DEPARTMENT OF ENGINEERING
 CITY OF SAN BERNARDINO
 13TH ST. WIDENING
 E ST. to ACACIA ST.
 CHANGE ORDER NO. 1

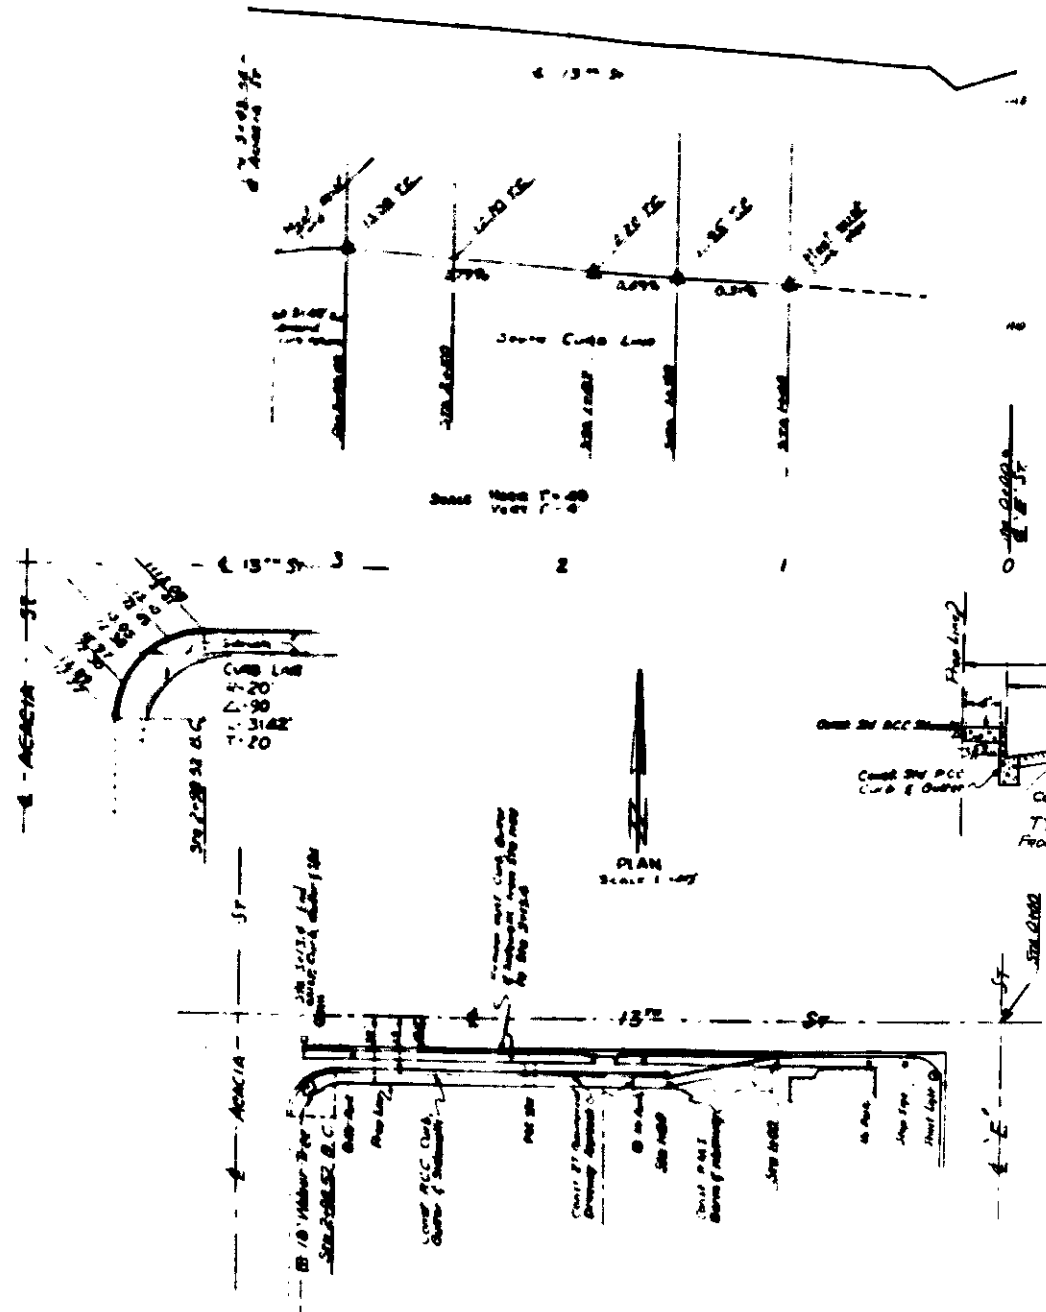
NOTE:
 BB-15 to be removed under this contract
 BB-16 to be removed and replaced under this contract.
 All work embodied on these plans shall be done in conformity with applicable provisions of Specification No. 2271

DEPARTMENT OF ENGINEERING
 CITY OF SAN BERNARDINO
 13TH ST. WIDENING
 ETH ST. TO ACACIA ST.
 CHANGE ORDER NO. 1

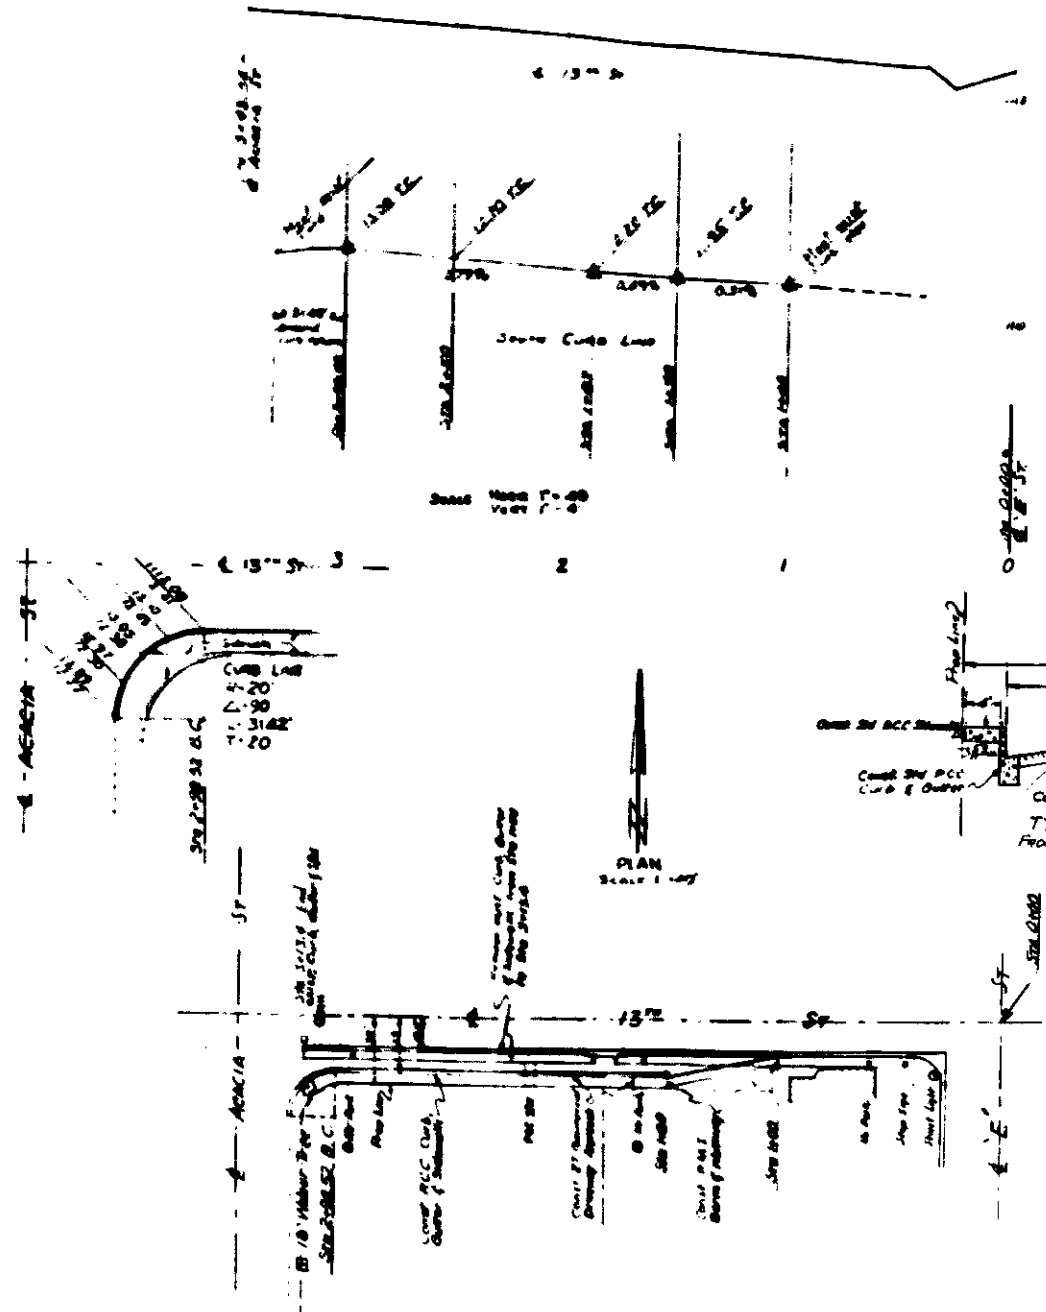
NOTE:
 BB-15 to be removed under this contract
 BB-16 to be removed and replaced under this contract.
 All work embodied on these plans shall be done in conformity with applicable provisions of Specification No. 2271

NOTE:
 BB-16 to be removed under this contract
 BB-15 to be removed and replaced under this contract.
 All work embodied on these plans shall be done in conformity with applicable provisions of Specification No. 2271
